MANUFACTURERS' RECEIVER TROUBLE CURES

VOLUME 4

A RIDER Publication

Fig. 34 — Sears Roebuck

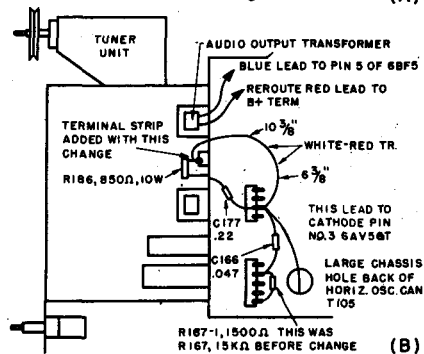
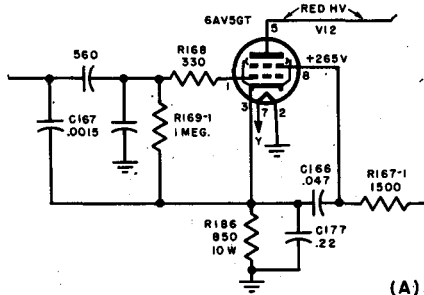
Later production of the above chassis incorporate the accompanying circuit change to decrease the dissipation in the 6AV5GT horizontal-output tube and increase the life of this tube. In every case where a model 106 or 107 with the above chassis is returned for service, this change should be made. The following parts, available as a kit (part

Fig. 44 — Sentinel

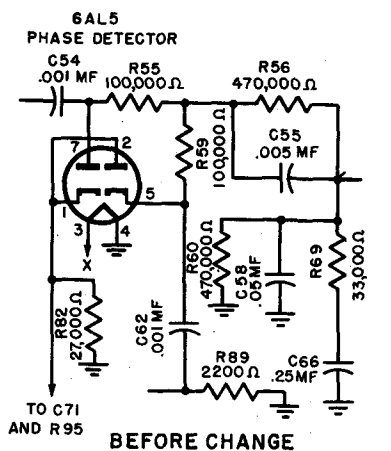
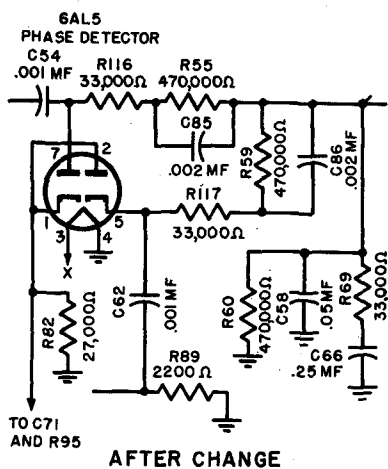
1. The .005- μ f capacitor *C55* and the 470,000-ohm resistor *R56*, parallel filter in the output circuit of the 6AL5 phase detector, are removed from the circuit.

Fig. 45 — Sentinel

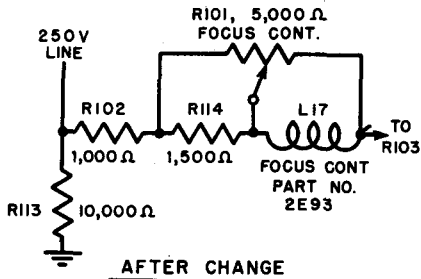
2. A 1,500-ohm, 5-watt resistor $R114$ is added in series with the

Fig. 57 — Shaw TV

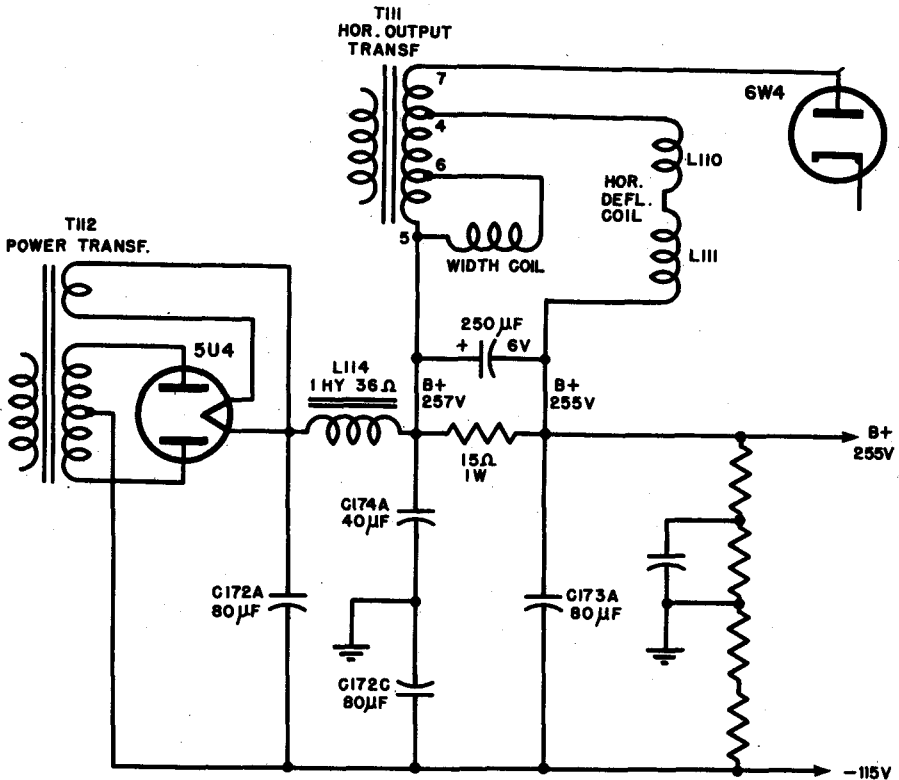
SHAW TV Chassis 224
Improved horizontal centering
 (see Fig. 57).

Fig. 58 — Shaw TV

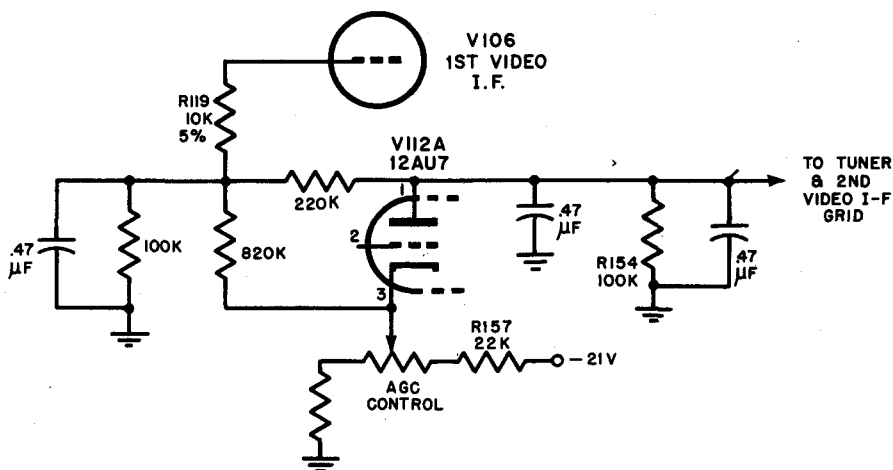
Buzz on either side of correct tuning position (see Fig. 58).

1. Mount a single-lug terminal strip under the nut of the discriminator can (closest end to *V112* age tube).
